AMENDMENTS TO THE DRAWINGS

Appln. No. 09/552,590
Amend. Dated: 3/18/04
Reply to Office Action of 12/19/03
Replacement Sheet

FIG. 5

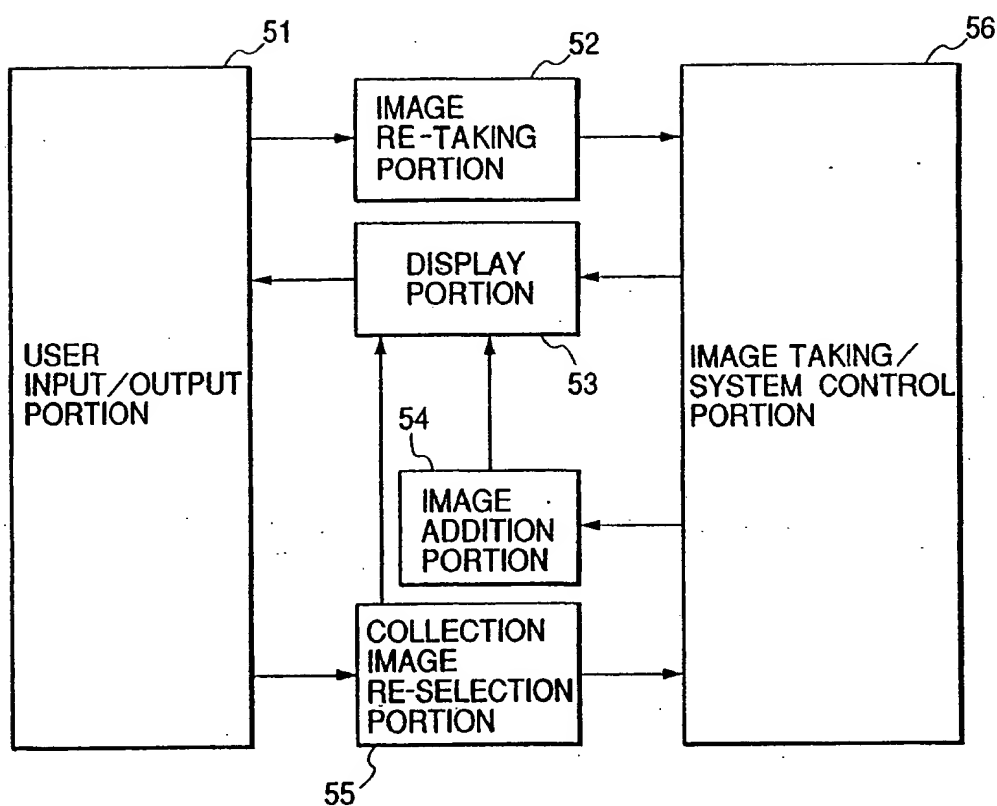
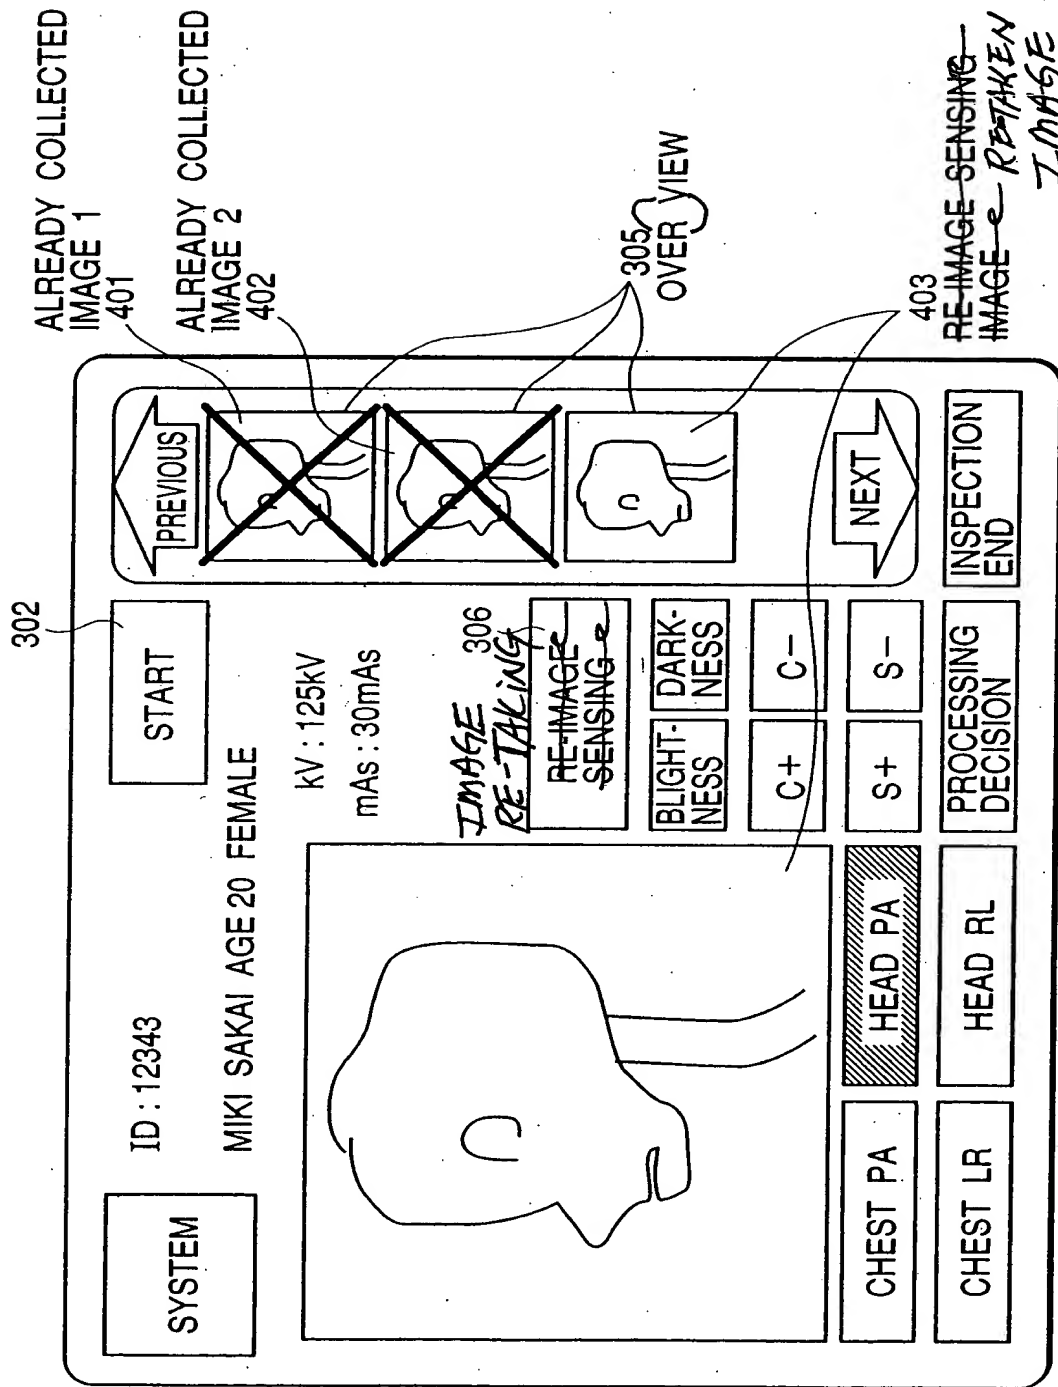
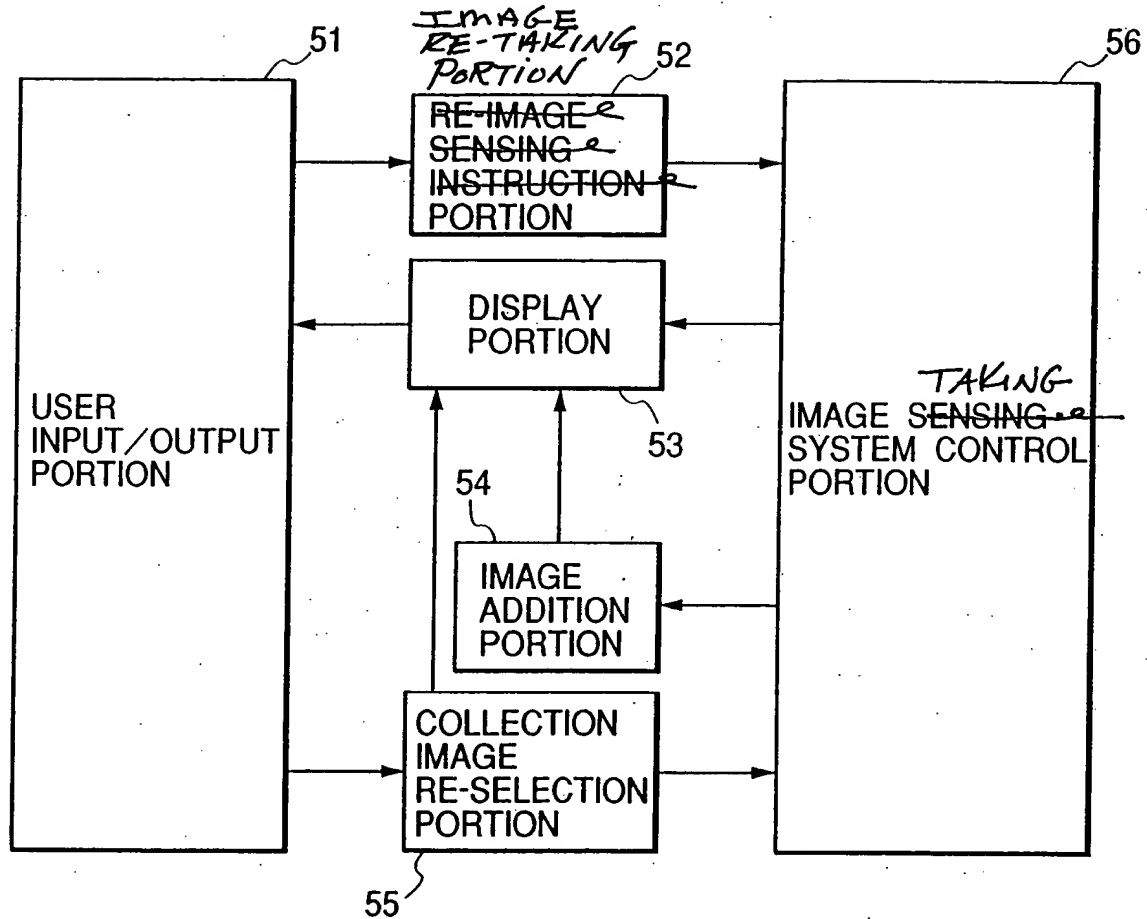
Fig. 5, change "RE-IMAGE SENSING INSTRUCTION PORTION" to --IMAGE RE-TAKING PORTION--, and change "IMAGE SENSING•SYSTEM CONTROL PORTION" to --IMAGE TAKING/SYSTEM CONTROL PORTION--.

FIG. 6

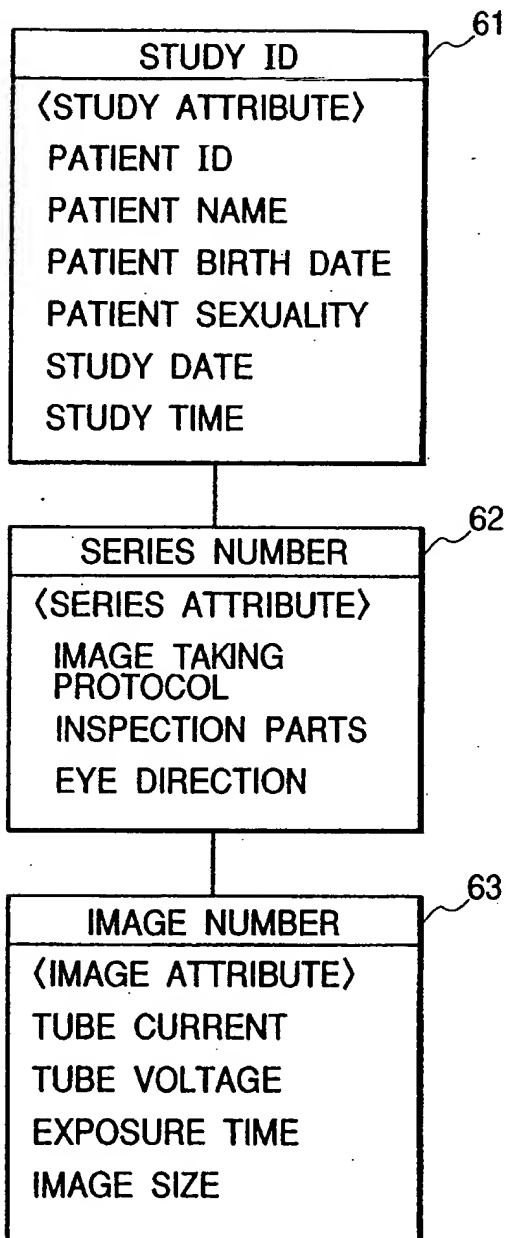
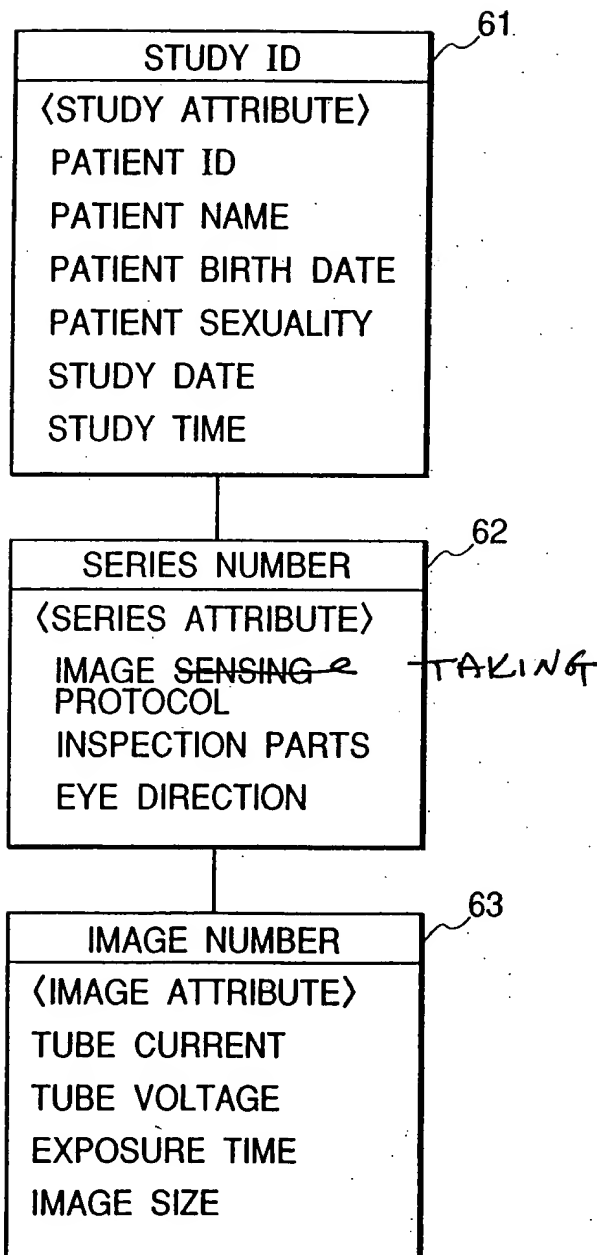
Fig. 6, change "IMAGE SENSING PROTOCOL" to --IMAGE TAKING PROTOCOL--.

FIG. 11

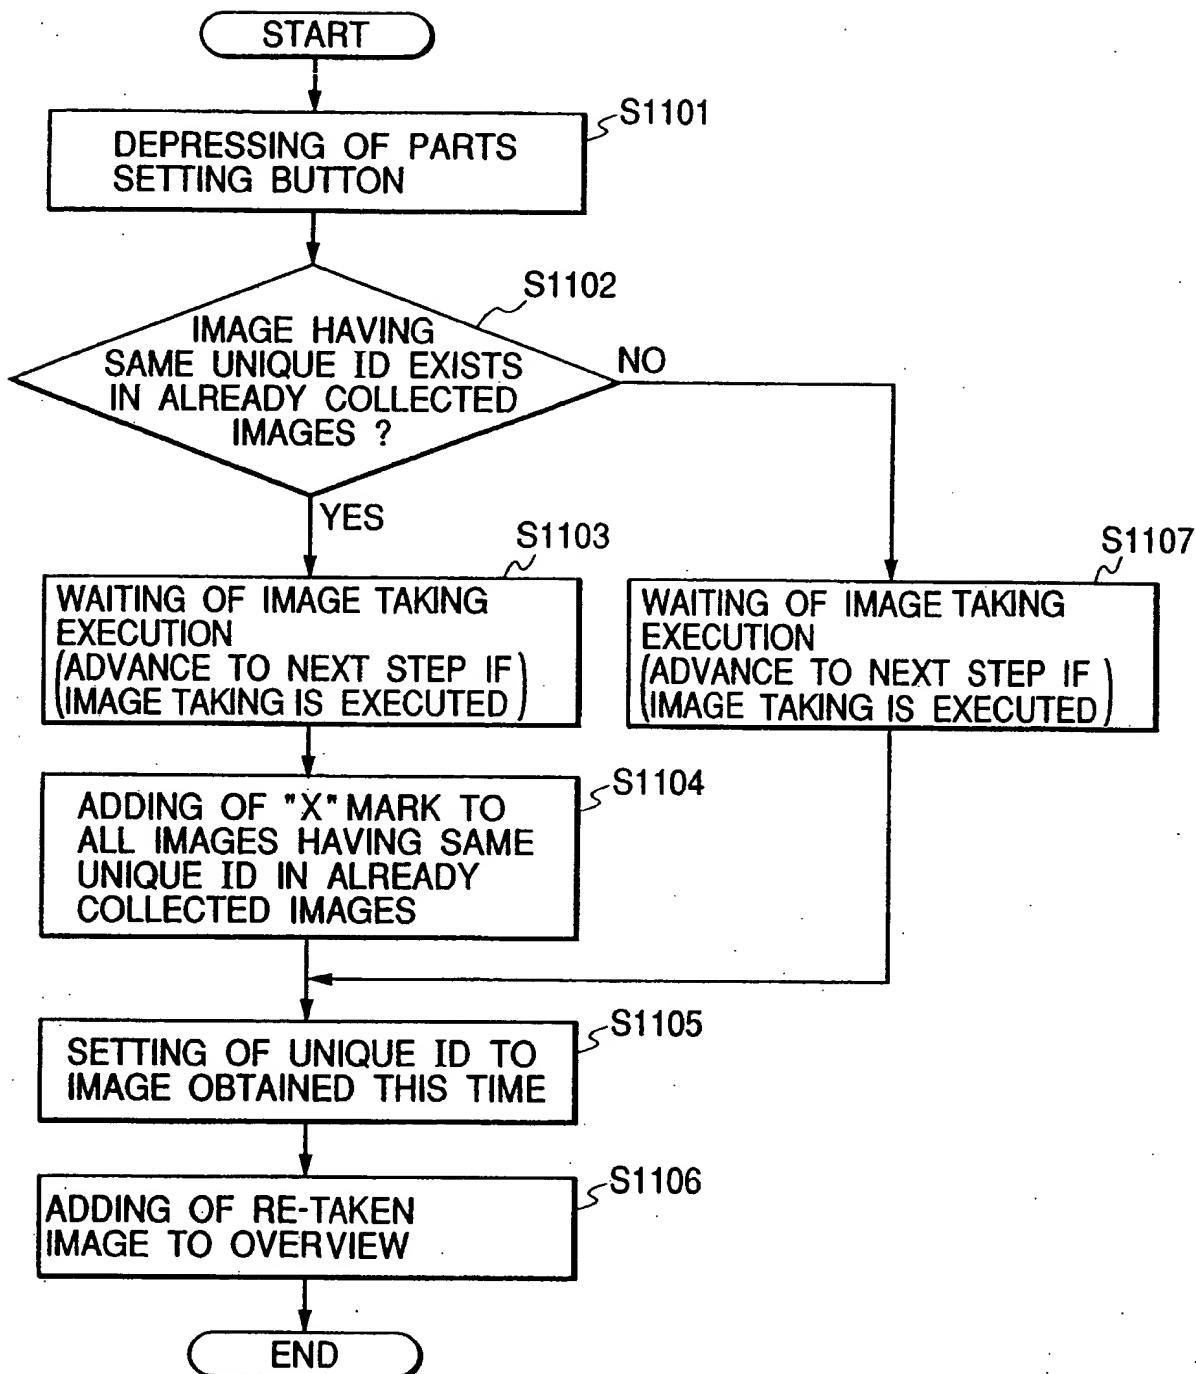
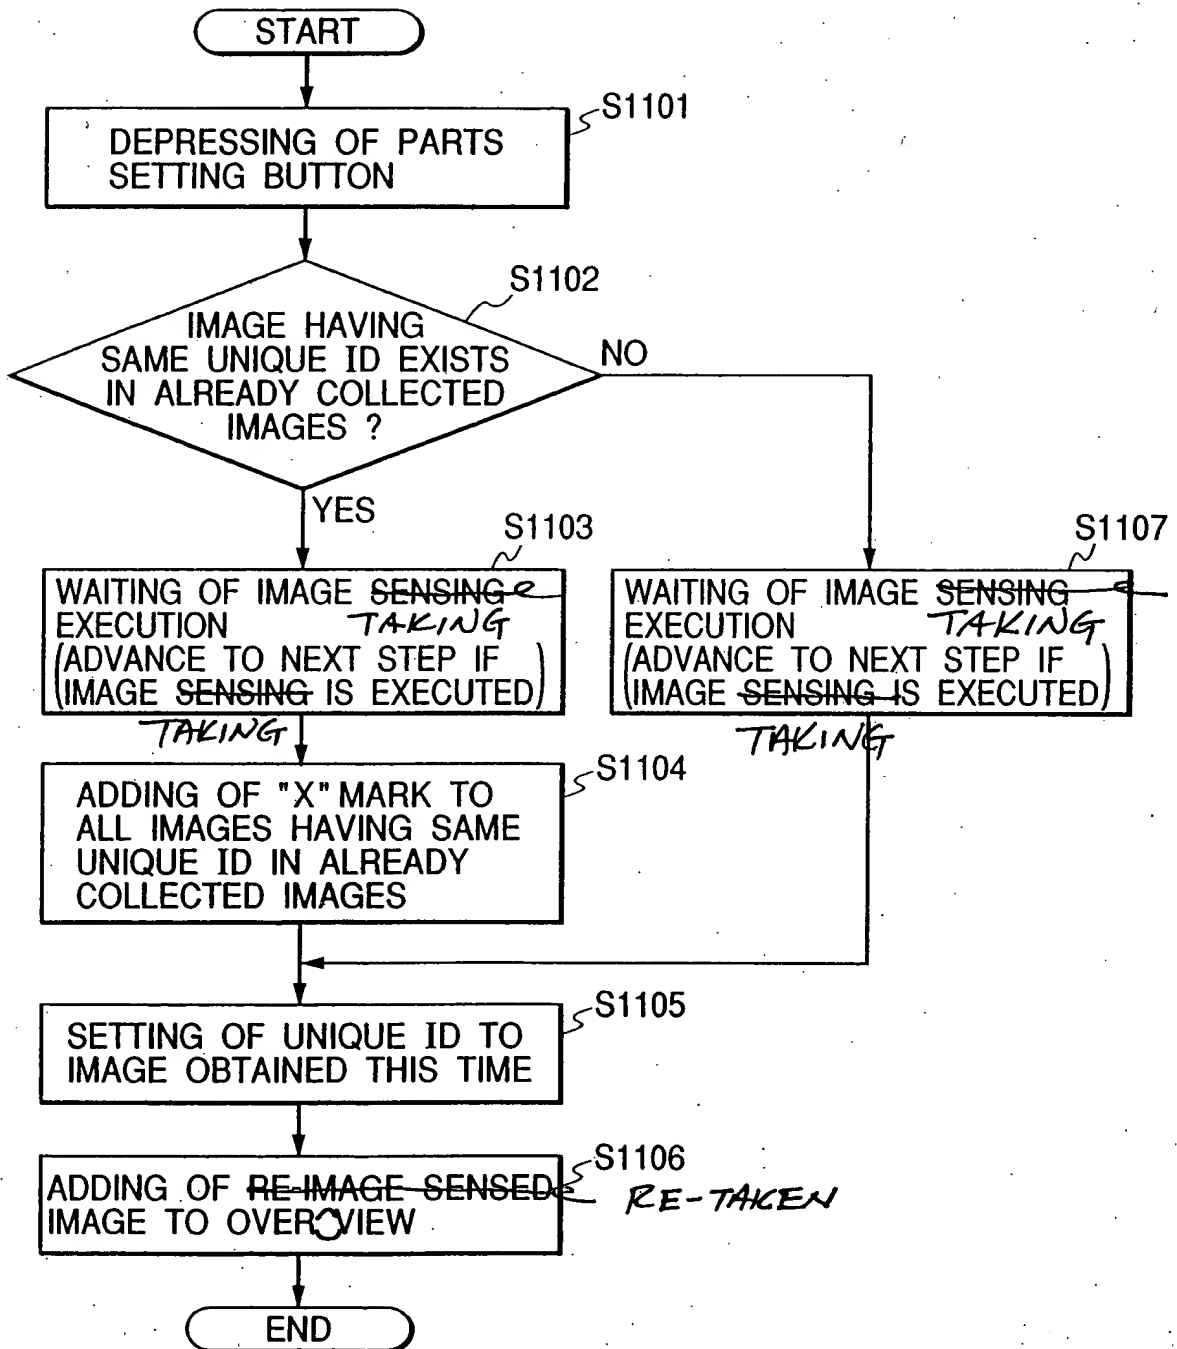
Fig. 11, change for S1103 "WAITING OF IMAGE SENSING EXECUTION (ADVANCE TO NEXT STEP IF IMAGE SENSING IS EXECUTED)" to --WAITING OF

IMAGE TAKING EXECUTION (ADVANCE TO NEXT STEP IF IMAGE TAKING IS EXECUTED)--, change for S1107 "WAITING OF IMAGE SENSING EXECUTION (ADVANCE TO NEXT STEP IF IMAGE SENSING IS EXECUTED)" to --WAITING OF IMAGE TAKING EXECUTION (ADVANCE TO NEXT STEP IF IMAGE TAKING IS EXECUTED)--, and change "ADDING OF RE-IMAGE SENSED IMAGE TO OVER VIEW" to --ADDING OF RE-TAKEN IMAGE TO OVERVIEW--.

FIG. 12

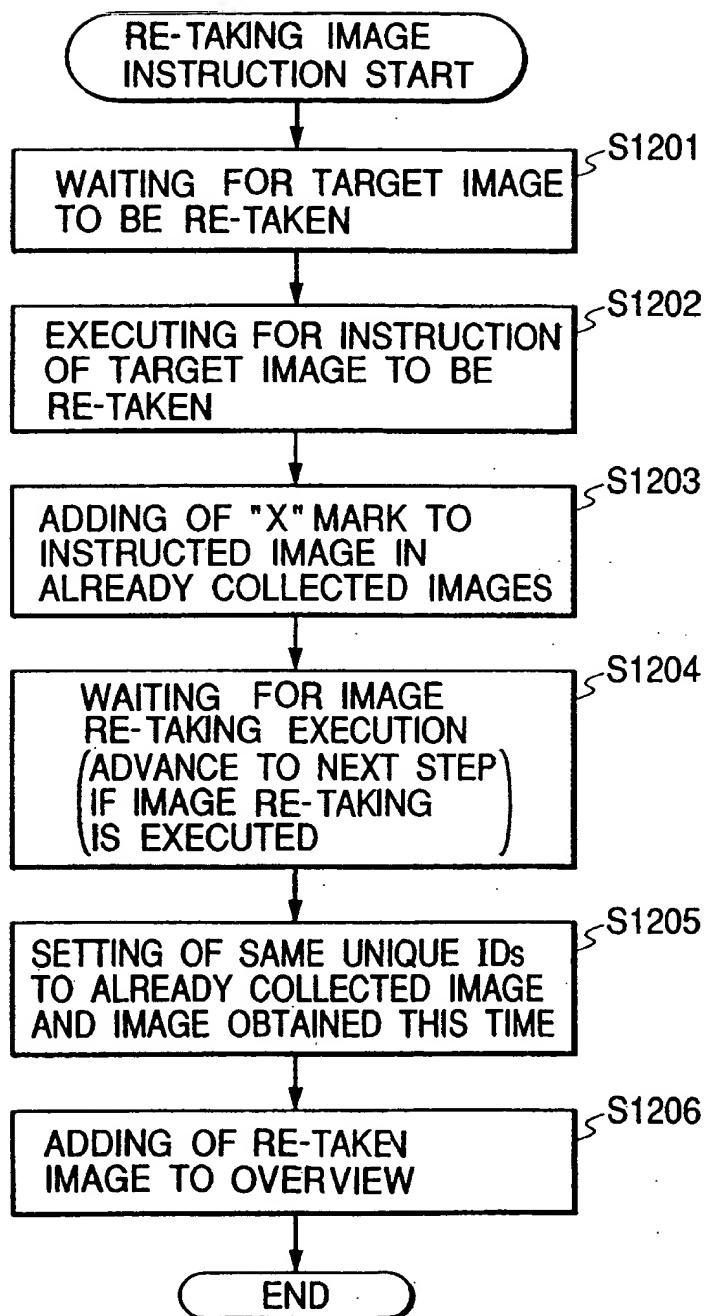
Fig. 12, change "RE-IMAGE SENSING INSTRUCTION START" to --RE-TAKING IMAGE INSTRUCTION START--, change "WAITING OF TARGET IMAGE TO BE RE-IMAGED SENSED" to --WAITING FOR TARGET IMAGE TO BE RE-TAKEN--, change "EXECUTING OF INSTRUCTION OF TARGET IMAGE TO BE RE-IMAGED SENSED" to --EXECUTING FOR INSTRUCTION OF TARGET IMAGE TO BE RE-TAKEN--, change "WAITING OF RE-IMAGE SENSING EXECUTION (ADVANCE TO NEXT STEP IF RE-IMAGE SENSING IS EXECUTED)" to --WAITING FOR IMAGE RE-TAKING EXECUTION (ADVANCE TO NEXT STEP IF IMAGE RE-TAKING IS EXECUTED)--, and change "ADDING OF RE-IMAGE SENSED IMAGE TO OVER VIEW" to --ADDING OF RE-TAKEN IMAGE TO OVERVIEW--.

FIG. 4

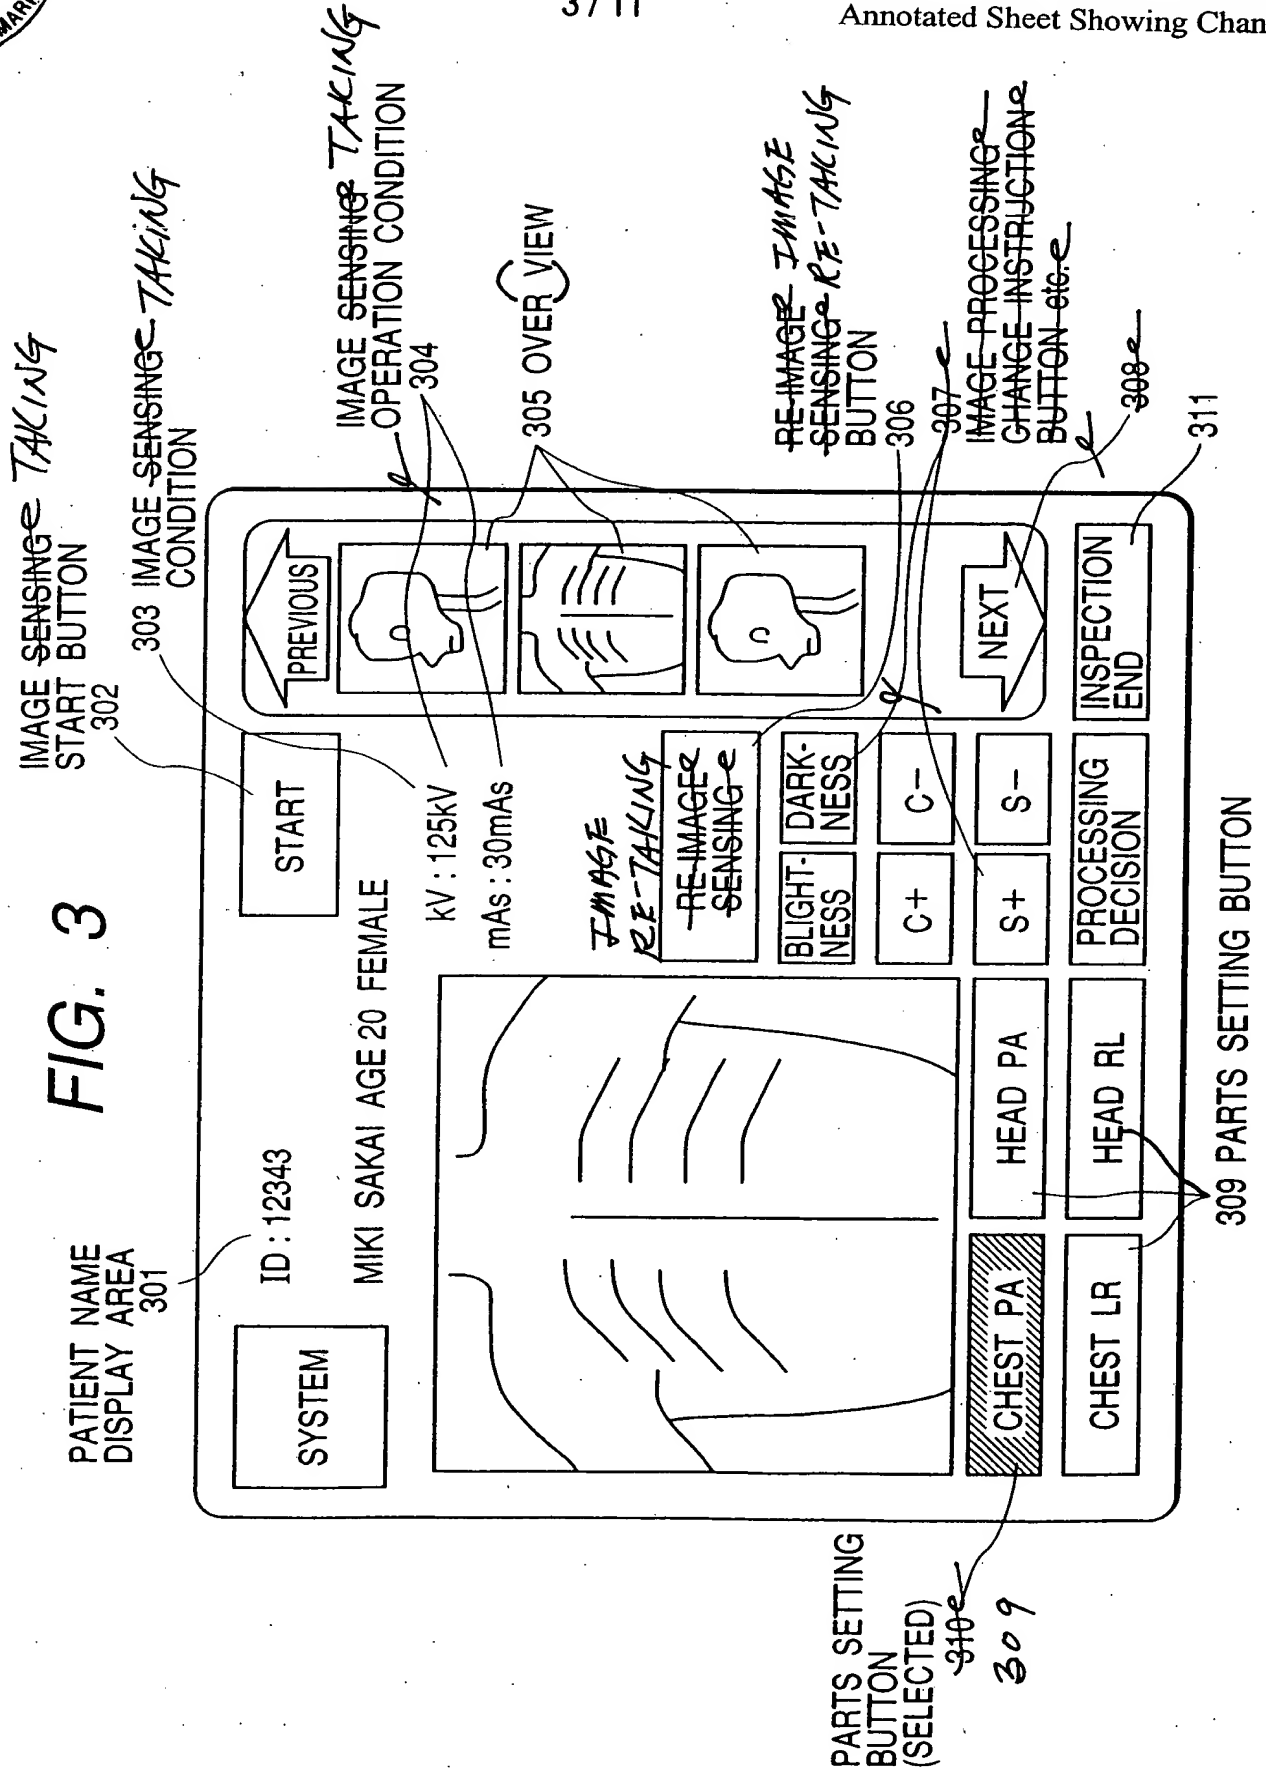
Fig. 4, change "RE-IMAGE SENSING" to --IMAGE RE-TAKING--, change "305 OVER VIEW" to --305 OVERVIEW--, and "403 RE-IMAGE SENSING IMAGE" to --RE-TAKEN IMAGE--.
